APPLICATION NO.	FILING DATE	FIRST NAMED INVENTOR	ATTORNEY DOCKET NO.	CONFIRMATION NO.
10/534,364	05/09/2005	Yoshinori Hishikawa	029650-170	4895

Office Action Summary	Application No. 10/534,364	Applicant(s) HISHIKAWA ET AL.	
	Examiner CHRISTOPHER D. KOHARSKI	Art Unit 3763

DETAILED ACTION

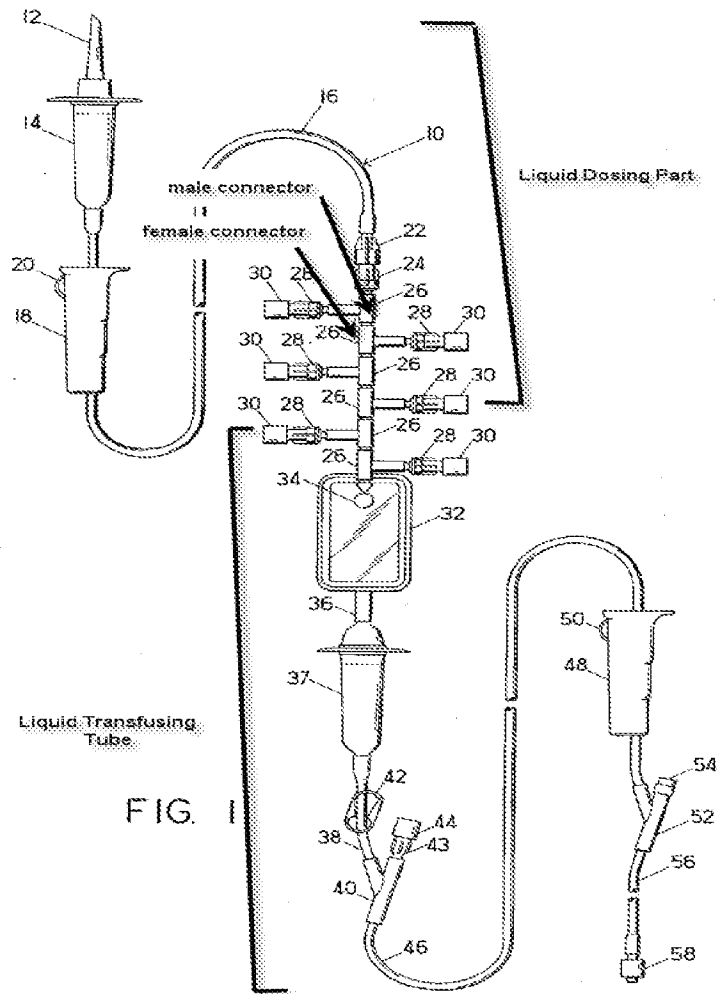
Claims 1 and 5-10 are rejected under 35 U.S.C. 102(b) as being anticipated by Gula et al. (USPN4,447,230). Gula et al. discloses an intravenous administration set assembly.

Regarding claims 1 and 5-10, Gula et al. discloses a liquid transfusing assembly (Figure 1) comprising: a tube constituting a liquid transfusing channel (fluid channel from element 26-46); a connector (26) provided at one end part of said tube; and a connection part (opposite side of element 26) provided on the other side of said tube and connected to the side of a containing part containing a transfusion (connected to spike 12); wherein said connector includes a male connector and a female connector (tee spike distal/proximal ends (26)), and the axis of said male connector and the axis of said female connector substantially coincide with each other (along longitudinal axis of center of tee spikes 26); and a liquid dosing part (assembly from 12-upper tee connector 26) for dosing a patient with said transfusion, said liquid dosing part having a liquid dosing part side connector (upper tee 26) capable of being connected to one of said male connector and said female connector of said connector of said liquid transfusing tube (46-26); wherein in the condition where one of said male connector and said female connector of said connector of said liquid transfusing tube and said liquid

dosing part side connector of said liquid dosing part are connected with each other, the other of said male connector and said female connector of said connector of said liquid transfusing tube can be connected to a liquid transfusing tube other than said liquid transfusing tube (Figure 1, see marked up figure below).

Gula et al. further discloses the liquid dosing part having a bacteria-removing filter (32, col 3, ln 55-65) provided on the downstream side relative to said liquid dosing part side connector; wherein said liquid dosing part has a mixing injection port (43) on the downstream side (defined as fluid flow from 12 to 58) of said bacteria-removing filter (32); and wherein said liquid dosing part side connector is branched into a plurality of parts (tees 26) so that a connector provided on the other end side of a tube having on its one end side a connection part connected to another liquid container (tee ends 28) other than said liquid container and said connector of said liquid transfusing tube can be simultaneously connected (Figure 1, col 3, ln 30-55, see marked up figure below).
